**BEFORE THE PUBLIC UTILITY COMMISSION OF OREGON**

2019 Integrated Resource Plan

Docket LC 70

**SIERRA CLUB'S COMMENTS ON PACIFICORP COAL ANALYSIS METHODOLOGY**

**Figure 1. Projected Battery Capital Cost Declines Relative to 2018, PacifiCorp and Lazard**

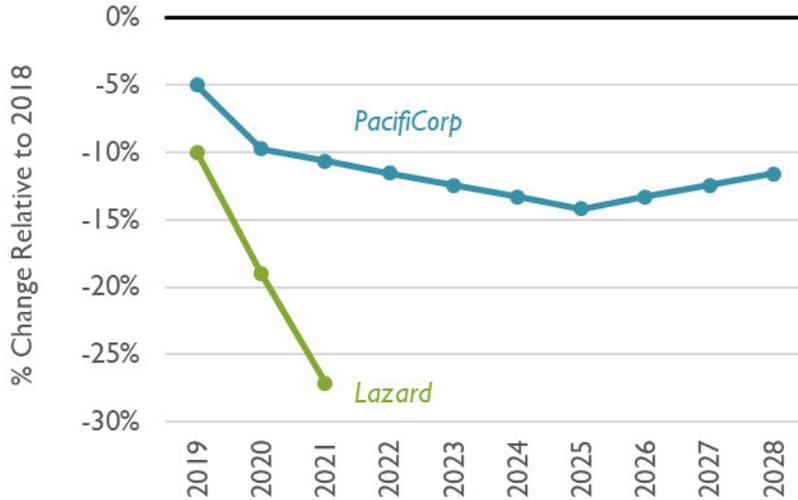
PacifiCorp's assumptions for the current and future capital costs of battery storage resources are too high. PacifiCorp's capital cost trajectory for one megawatt (MW) lithium-ion batteries starts between \$682 and \$1,308 per kilowatt-hour (kWh), depending on the MWh size of the battery.<sup>6</sup> In contrast, the latest industry-standard levelized cost of storage report from Lazard indicates current lithium-ion capital costs of approximately \$500 per kWh.<sup>7</sup> PacifiCorp's estimates are about 35 to 160 percent higher than Lazard's estimate.

Furthermore, PacifiCorp uses low estimates for future battery storage cost declines. The Company assumes annual declines of about 5 percent in 2019 and 2020, followed by cost declines of one percent per year in following six years and then cost increases starting in 2026.<sup>8</sup> Lazard, on the other hand, forecasts lithium-ion capital cost declines of about 10 percent per year between now and 2021.<sup>9</sup> Thus, between 2018 and 2021 Lazard expects lithium-ion costs to decline by about 27 percent whereas PacifiCorp assumes that battery costs will never be more than 14 percent lower than they are today (see Figure 1).

PacifiCorp must review its battery and solar cost assumptions and revise them to be in line with the forecasts of Lazard, NREL, and other independent industry experts. This is an important near-term step, as battery and solar resources constitute potential replacement options for retiring coal capacity.
